# Gondar Gardens Briefing Note – 29<sup>st</sup> October 2018

## Sustainability

CBC Response to GLA Energy Memo: Stage 1 Consultation – 05/12/2017

Figure 1 – The Monthly Heating Demand and CHP/Boiler Contribution.

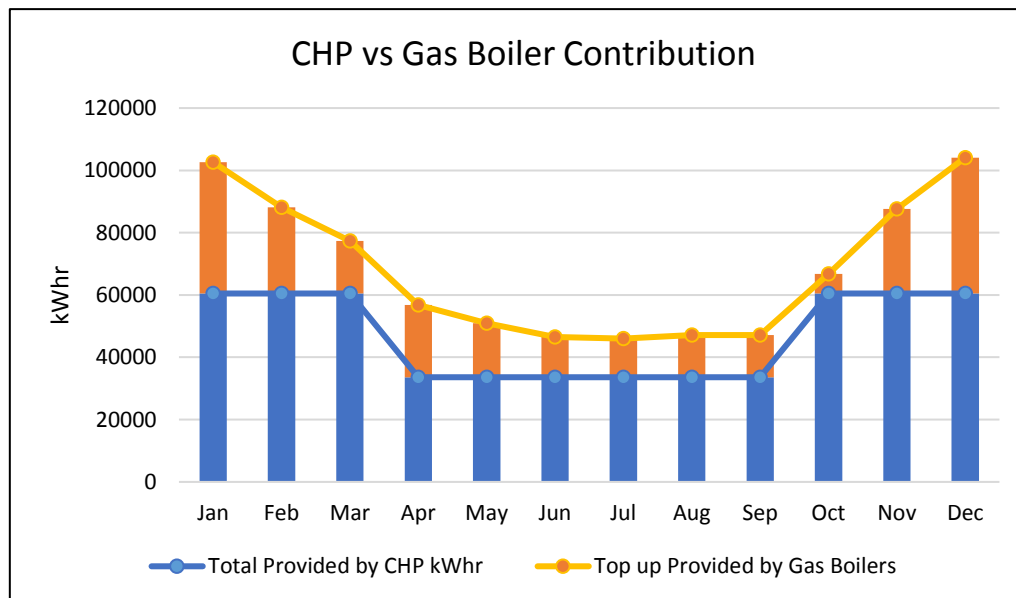
13. The applicant should also provide the analysis used to determine the size of the CHP including, suitable monthly demand profiles for heating, cooling and electrical loads. The plant efficiencies used when modelling carbon savings should be based on the gross fuel input for gas rather than the net values often provided by manufacturers.

The CHP system is designed to contribute 55% of the combined residential heating and hot water demand, as well as 20% of the heating load and 100% of the hot water load for the non-residential element. *Figure 1* and *Table 3*, below, displays the calculated combined monthly heating and hot water load profile for the residential and commercial elements of the Gondar Gardens development and the contribution of both the CHP system and gas boilers. The CHP units (displayed in blue in *Figure 1*) provides the baseload and gas boilers providing the top up requirements.

Figure 2 - Current vs Potential PV Area

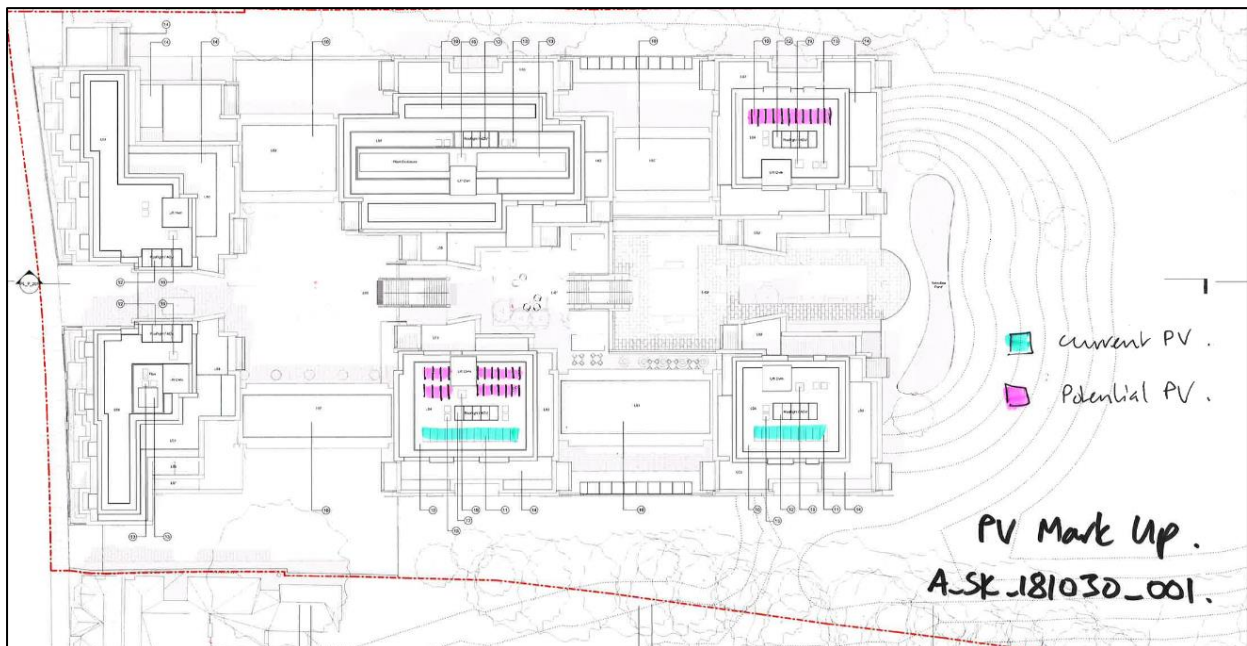
17. Based on the roof layout provided there seem to be much more roof areas available for a PV installation. Given the shortfall in CO<sub>2</sub> emissions, the applicant should ensure that the on-site PV provision has been maximised.

The inclusion of additional PV panels beyond the 5 kWp array currently proposed at roof level has been investigated. Figure 2, below, displays a sketch showing the roof areas that are currently specified to house the 5 kWp PV system and the areas that could potentially house further PV panels that are not intended to house plant equipment or are not exposed to shading.

If the potential PV areas are utilised, the PV array would increase from 20 panels to 49 panels, thus increasing the array to a 13.475 kWp array from the proposed 5 kWp system. Within Appendix A, an updated BRUKL is presented for the 13.475 kWp PV 'stage'. Similarly, updated calculations are displayed within Appendix A, accounting for the increase in PV cells, which shows an annual total CO<sub>2</sub> saving of 4.79 Tonnes from PV which is an increase of 2.13 tonnes saved by the initial 5 kWp system proposed.

Figure 3 – Commercial SBEM Model

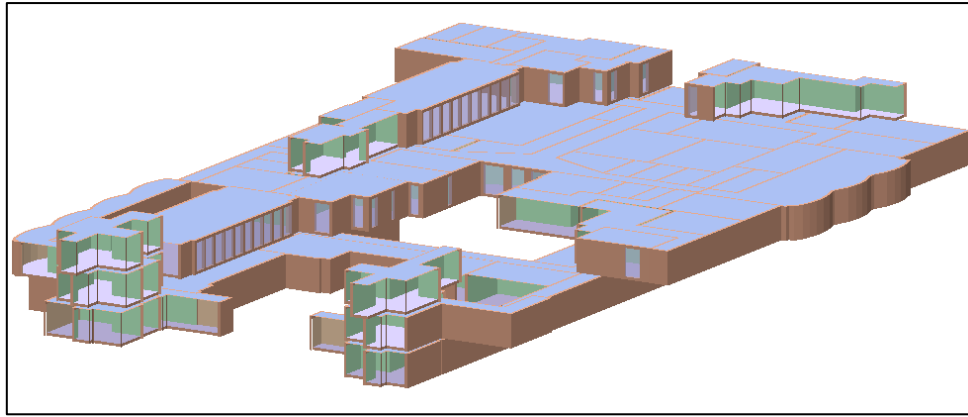
## 23. Clarification regarding the applicable part of development modelled & confirm relevant floor areas (quantum in data sheet shows shortfall from total commercial areas stated).

The commercial zones of the development have been modelled in entirety by a Cudd Bentley CIBSE Low Carbon Energy Assessor, who are registered to carry Level 5 Energy Assessments. The software used to carry out the modelling is Bentley, HEVACOMP, Version V8i, SS1 SP5 which is an accredited software. Below in Figure 3 is the commercial model.

The floor areas accounted for within the commercial part of the development are as follows:

- Front of House = 1,866 m<sup>2</sup>
  - Back of House = 490 m<sup>2</sup>
  - Other (Circulation/lifts/stairs) = 2,356 m<sup>2</sup>
- Therefore, Total commercial area = 4,712 m<sup>2</sup>
